Detailed Site Plan

Maryland Park, Lot 110

DSP-18030

STAFF REPORT

Figure 1: Proposed Architectural Elevations

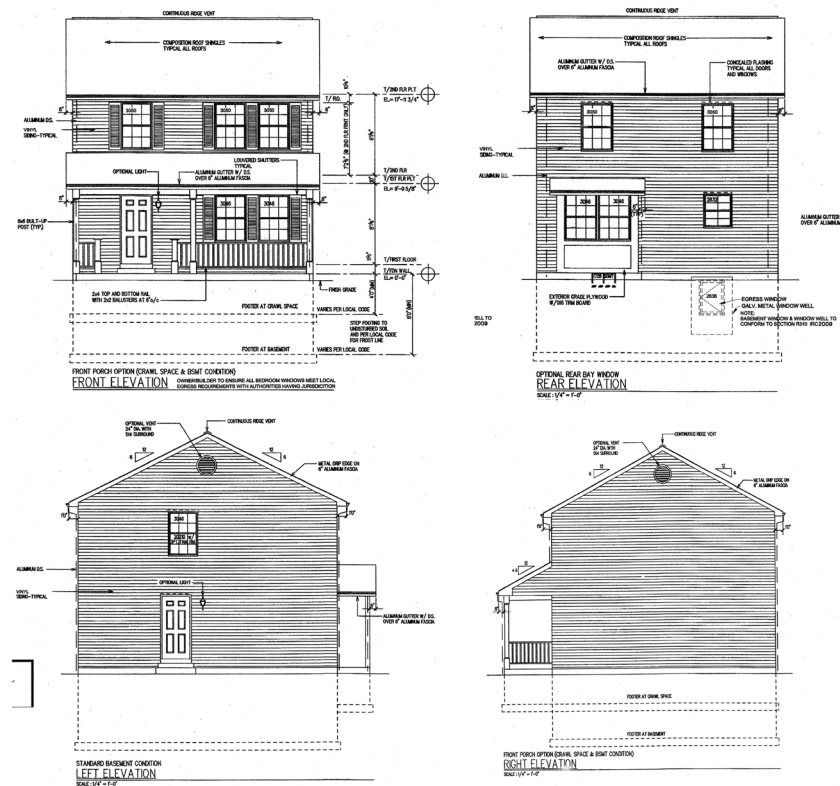
The applicant has proposed a two-story, 2,184-square-foot, single-family dwelling with a gabled roofline that is approximately 28 feet in height. The use of durable, quality materials is proposed on the building and includes vinyl siding, aluminum, and glass, with an entrance proposed on the front building face. The building is accented by a covered porch, which spans 27 feet along the front width of the house. The front elevation is further accented by a combination of five windows and louvered shutters that break up the face of the building. The rear and side elevations are finished with vinyl siding matching the front elevation, and includes an option for a bay window off the dining room on the rear elevation. The left-side elevation includes a second entry and a single window on the second story, while the right elevation does not include any architectural features. Staff recommends a minimum of two architectural features on the right-side elevation, to enhance the appearance of the building. Features such as accent, or standard windows will add visual interest to the elevation while increasing natural light in the house. A condition is included herein requiring this modification.

In addition, it is noted that two front elevations have been submitted, but they do not accurately reflect what is being proposed. These architectural elevations include the Mt. Airy II value plan and the Mt. Airy II enhanced plan. The value plan offers a second entry on the left-side elevation, and a small covered porch on its front. The enhanced plan offers an option with a garage and family room on the left elevation, with a deck on the rear, and covered porch on the building's front. The submitted application proposes a combination of options shown in both the value and enhanced plan, and should clarify which options are being included with this DSP. A condition requiring clarification is included in the Recommendation section of this report.

- d. Provide a minimum of two architectural features on the right-side elevation.
 - e. Provide a photometric plan demonstrating that appropriate lighting levels are being proposed site and that no light spill-over is proposed onto adjacent properties, to be reviewed by the Urban Design Section as the designee of the Prince George's County Planning Board.

- h. Revise the detailed site plan to correctly identify and demonstrate all of the approved alternate transit development district standards.
 - i. Revise the architectural elevations to clearly identify the building options and finishes proposed with this detailed site plan and reflect these improvements on a revised housing template.

Figure 2: Proposed Building Setback

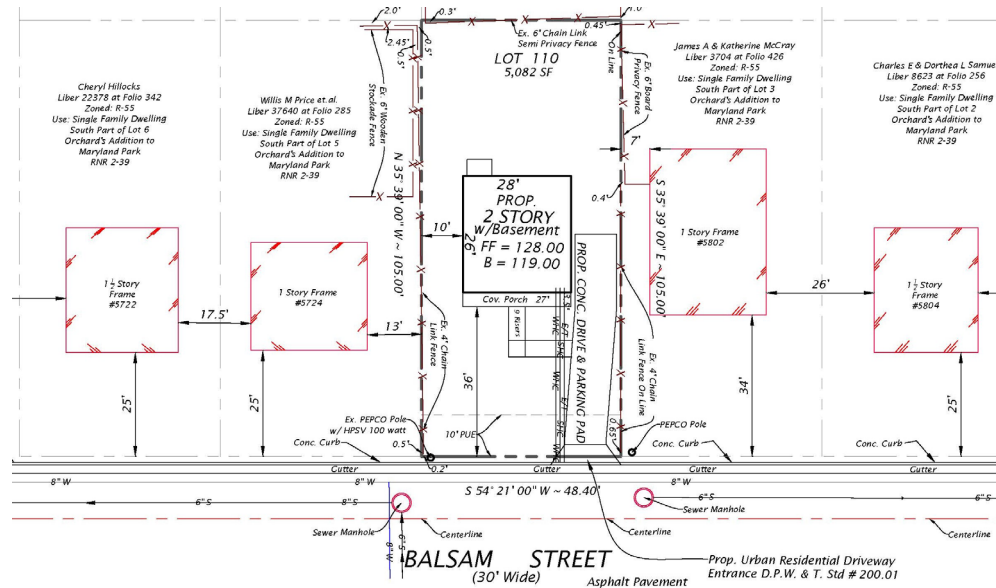
The side yard setbacks are approximately 10 and 12 feet in width, and the rear yard setback is 38 feet. The setbacks conform to the above requirements but are not clearly delineated on the plan and should be dimensioned for clarification. A condition requiring the applicant to dimension the building setbacks on the DSP has been included herein.

The building setback from the curb is not delineated on the plan; however, it is shown at approximately 36 feet from the right-of-way of Balsam Street to the covered front porch. The proposed building does not meet this standard and an amendment is necessary. Staff recommends that the amendment be approved, as the proposed building location is generally consistent with the adjacent properties and will not substantially impair the implementation of the Capitol Heights TDDP.

- A. APPROVE the alternative transit district development standards for:
 - 1. Urban Neighborhood—Single-Family Detached Character Area, Build-to-Line: To allow the building setback from the face of curb to be increased from 10–15 feet to a maximum of 37 feet.

- b. Provide a dimension for the side and rear setbacks of the building.
 - c. Provide dimensions on the driveway showing it to be a minimum of 9.5 feet wide and 38 feet long, outside of the public right-of-way.
